Flat Creek Solar

94-C Exhibit 8

# Cordelio/Suneast/Flat Creek Solar Project

Visual Impact Study and Site Plan Review and Findings

Zone 3 – Image set taken from documented location that Cordelio/Suneast noted as to where they took their images, they will fall in line with impacted view in Zones 1 and 2

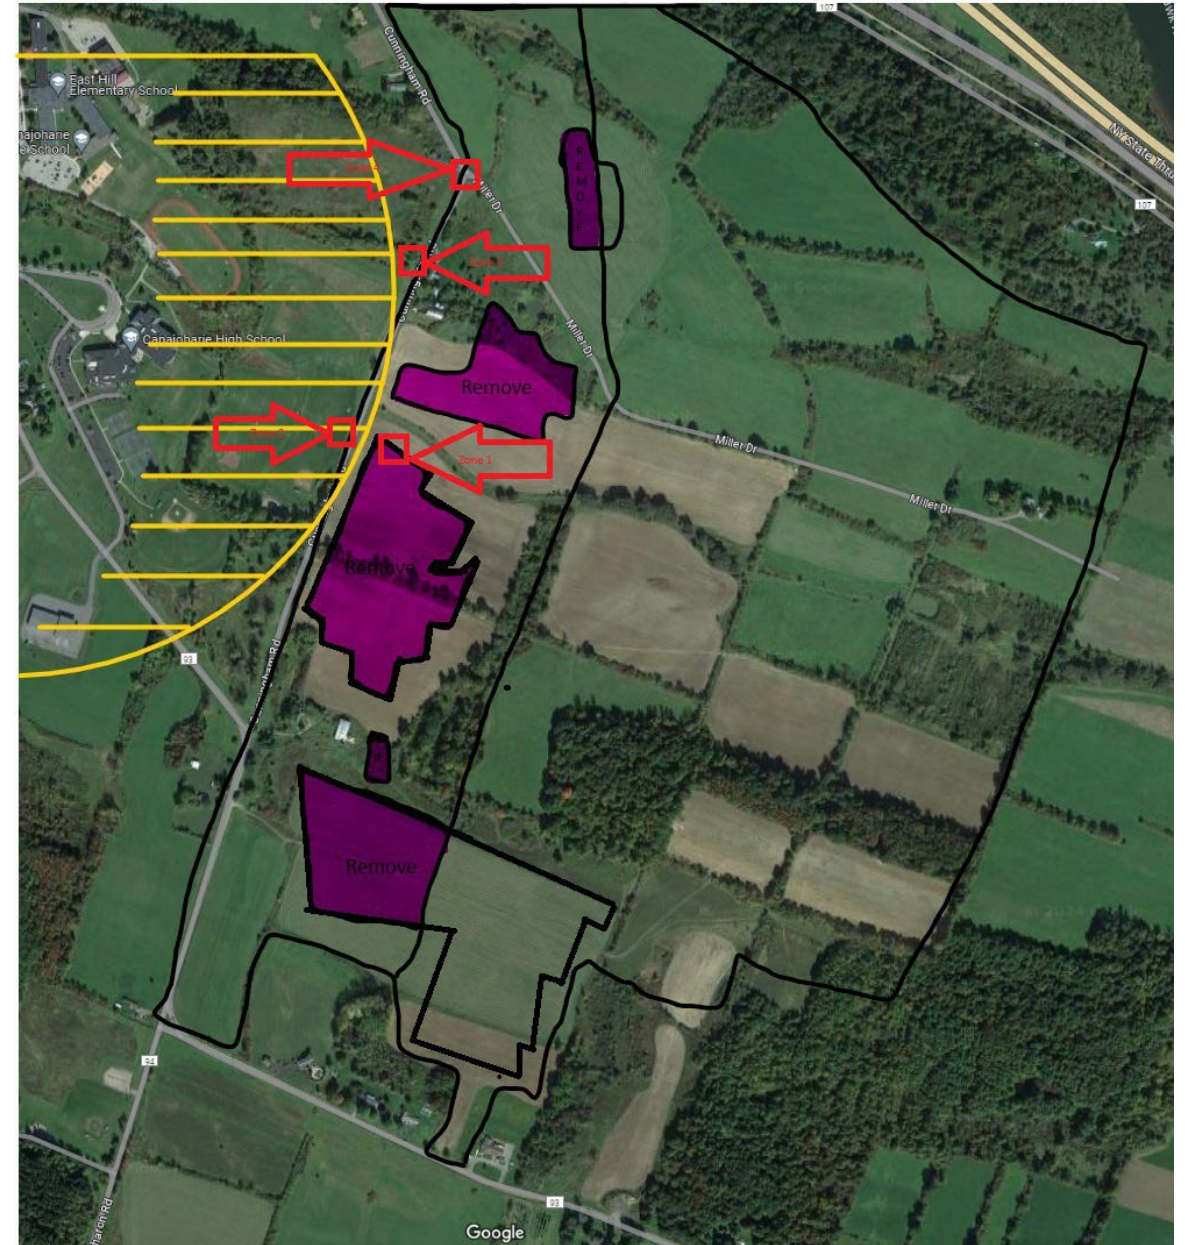
Proposed Development areas 1, 2, 3, 4 and 5 are areas of concern, shown in image in this slide highlighted with fuchsia, they have been noted with "Remove". Images have been taken from area 1, 2, 3 and 4 showing impact.

Third set was from 45 feet into Canajoharie CSD athletic field. Very high visibility impact to the School as well as a very heavily traveled road. Impact to this area will be multifaceted, both visually and for traffic flow (during construction).

- Based on our assessment and review, the Town requests that “Zones 1 through 3” as noted in previous slide in fuchsia, ***be relocated*** to the east, behind secondary hedge row already existing for most of the developed area. Area where hedge row is not existing, new 12-foot hedge barrier be created both in field and at road to eliminate any impact to Canajoharie Central School.
- Zone 4, while less critical in impact, but still high impact noted, should receive 12-foot hedge barrier at road to ensure impact is minimized.
- The Town also requests that all electrical lines, transformers, cabinets, inverters, and associated equipment should also be placed below ground in Zones 1 through 4. [The wetland delineation report](#) seems to indicate a preference for underground gathering lines but also refers to “possibly overhead” lines.

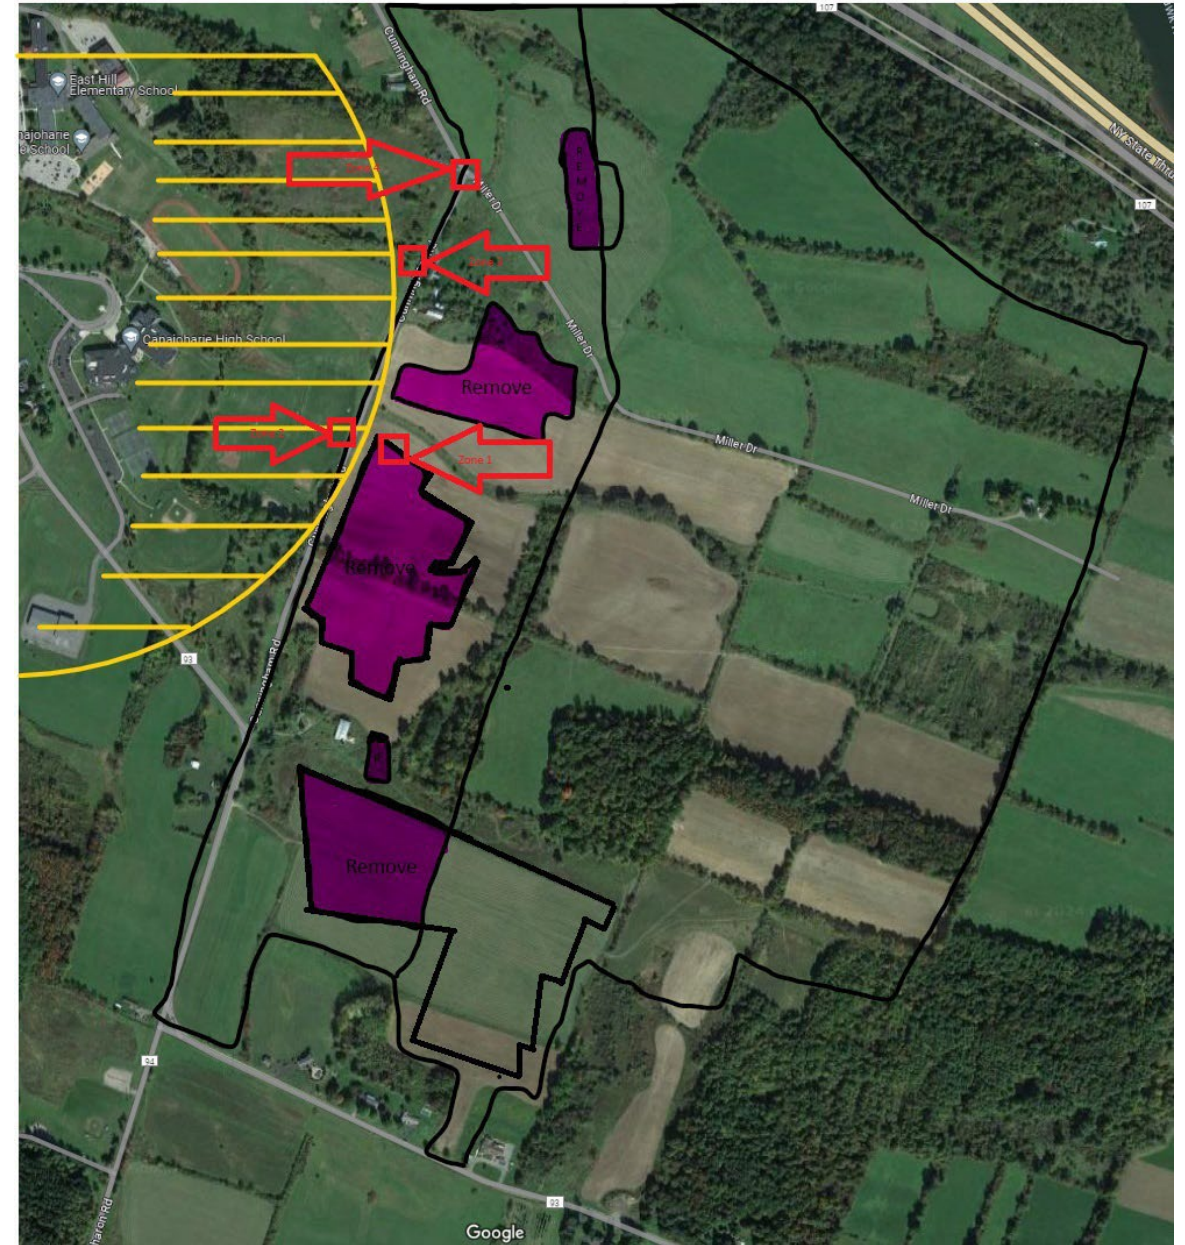
**Inverter/Transmission Facility Visibility** – There is major concern of inverter/transmission facilities being visible in the impacted areas along with the notation that area in question is partially deemed wetland as shown in the wetland delineation report, there is a potential of “Overhead transmission” being used in this area

**Noise Impact** – There is major concern on Noise Impact during construction and post construction in the areas noted above. During construction and driving of posts and or construction work could will be a major concern for the town/village and most of all school. Post install while there should be minimal noise generation, there is still concern of any noise generation from Invertors and Transmission Facilities within a ½ mile distance of the school and athletic fields.

- The panels proposed for this area should be designed and sited and/or appropriate mitigation provided such that glare, especially as may be experienced to locations west of Cunningham Rd, is *avoided* at all times of the year.
- The proposed inverters should also be sited to avoid or minimize noise impacts. Inverters can produce noise levels of 65 dba at about 3 feet.

For example, the inverter nearest the school property is located about 730 feet north of Carlisle Rd of the Cunningham-Carlisle Rd intersection and about 170 feet offset to the east of Cunningham Rd. It is about 430 feet from the school fields. While at this distance from the school fields any noise (presuming max. emission of 65 dba at 3 feet) from this inverter can be expected to be small, the Applicant should address this as part of the application, given proximity to the school and fields complex.
